**CITY OF LA VISTA**  
**MAYOR AND CITY COUNCIL REPORT**  
**MAY 16, 2023 AGENDA**

<b>Subject:</b>	<b>Type:</b>	<b>Submitted By:</b>
APPLICATION TO AMEND PUD SITE PLAN LB SOUTHWEST, LLC LOT 2, WOODHOUSE PLACE AND LOTS 1-2 WOODHOUSE PLACE REPLAT 1	◆ RESOLUTION ◆ ORDINANCE RECEIVE/FILE	CHRISTOPHER SOLBERG DEPUTY COMMUNITY DEVELOPMENT DIRECTOR

RE: Planned Unit Development Amendment – Initial Review Letter  
Lot 2 Woodhouse Place and Lots 1 and 2 Woodhouse Place Replat 1

REFERENCE: Woodhouse Place  
Planned Unit Development (PUD) Amendment  
Comment Response - Initial Review  
Job No. 0116050.01-020

PLANNED UNIT DEVELOPMENT  
GRADING PLAN

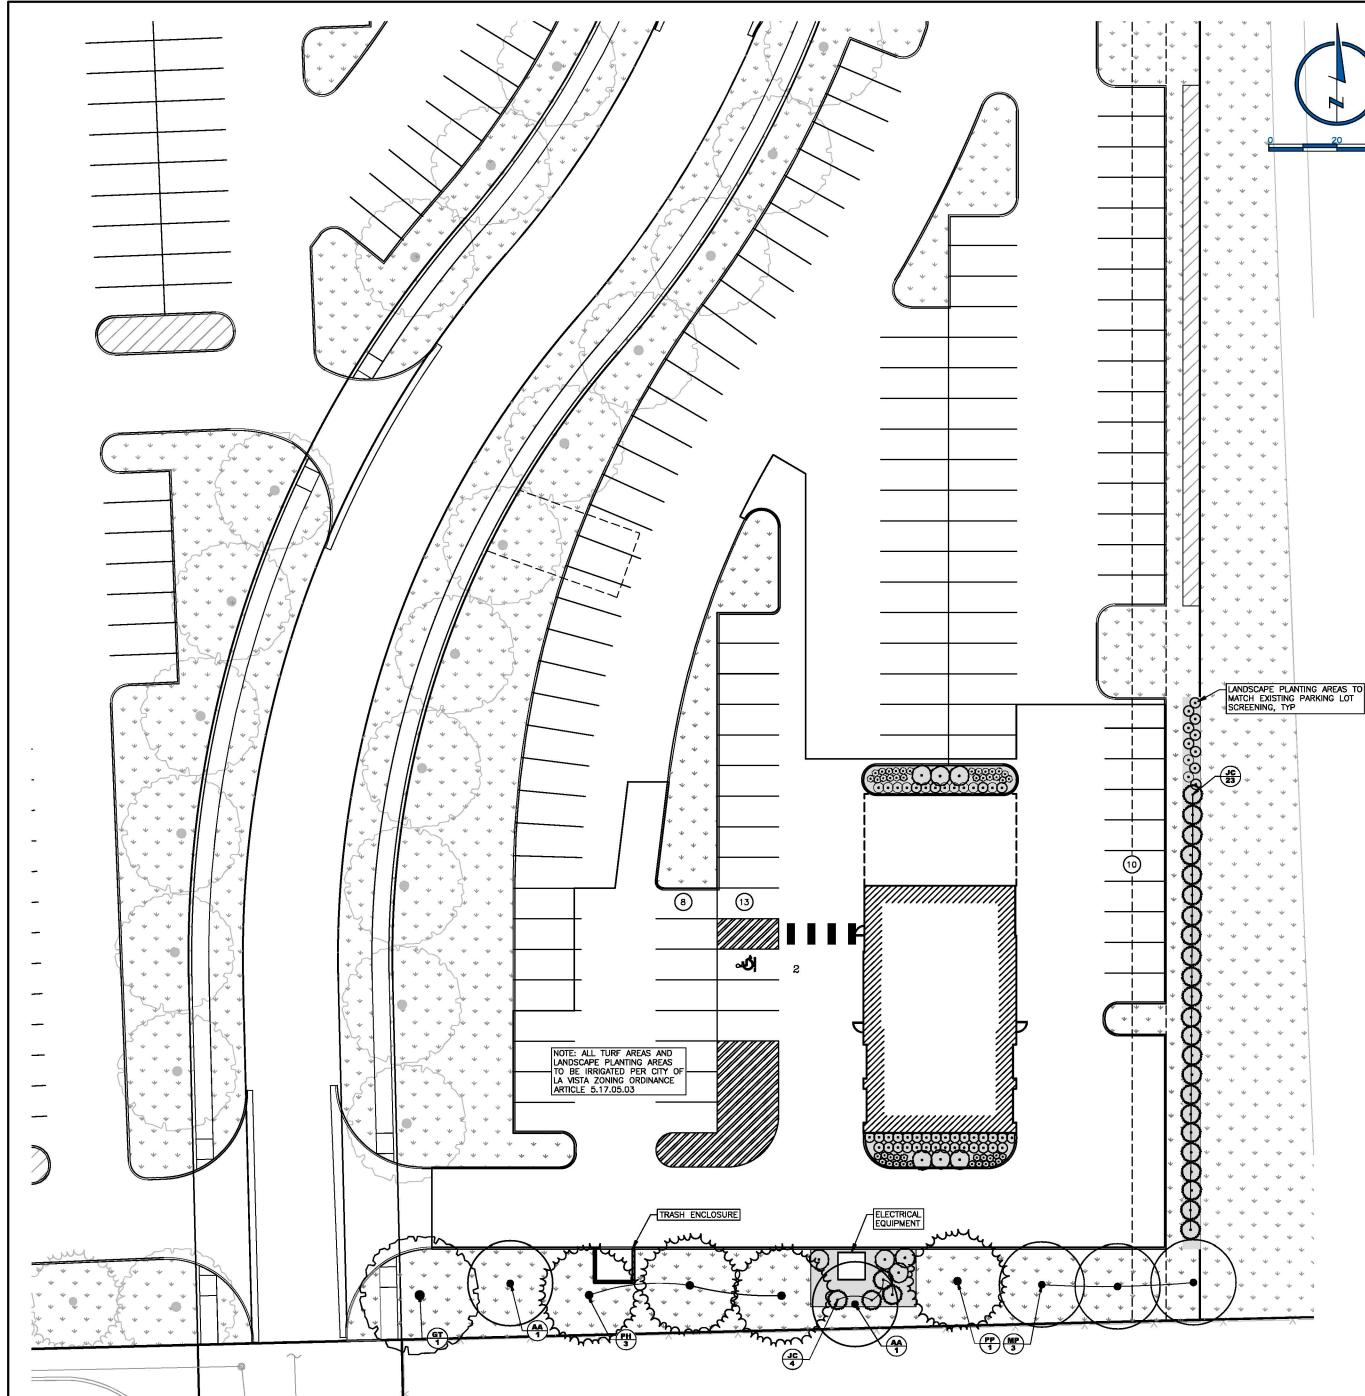
4. Please show the means of stormwater conveyance for the proposed project. The locations of any existing and/or proposed drainageways should also be provided (Section 5.15.05.02 (10)).

**RESPONSE:** A utility plan and grading plan have been provided illustrating the schematic storm sewer layout and drainageways.

**ENTERPRISE LANDSCAPE PLAN**  
WOODHOUSE PLACE  
SARPY COUNTY, NEBRASKA

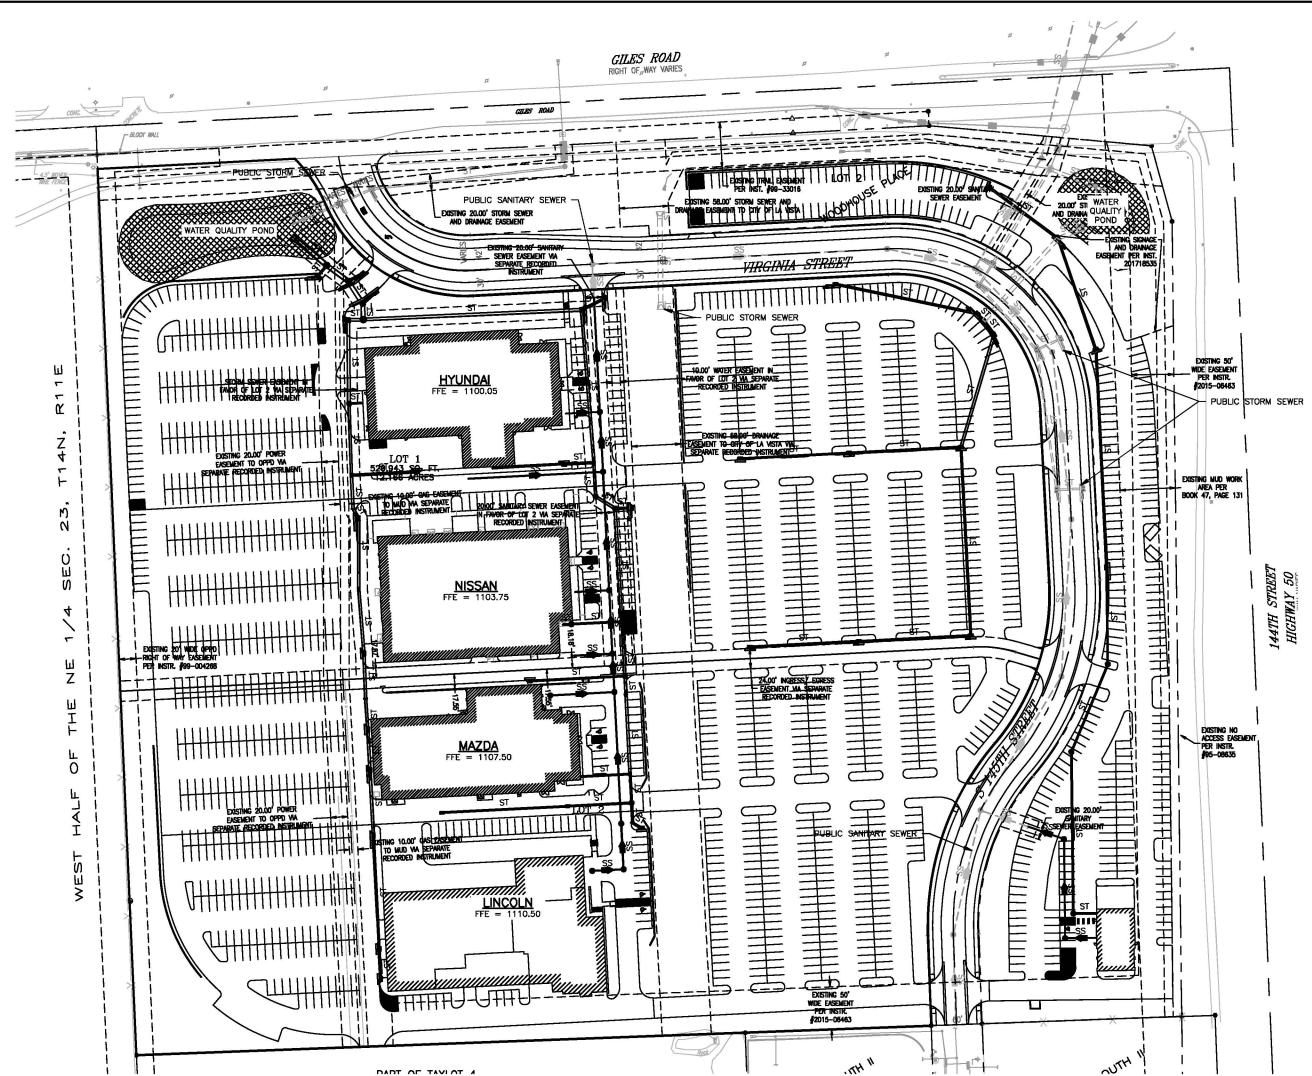
- a. Significant portions of the proposed plantings are straight line, which is not in compliance with 4.III.F.

**RESPONSE:** The landscaping plan varies plantings within the landscape islands and the perimeter landscaping to the south. The landscaping along 144<sup>th</sup> Street provides screening for the garage doors and is consistent with the current planting arrangement.

**RESPONSE:** All landscaped areas will receive irrigation. The irrigation limits are noted on the included Enterprise Landscape Plan.
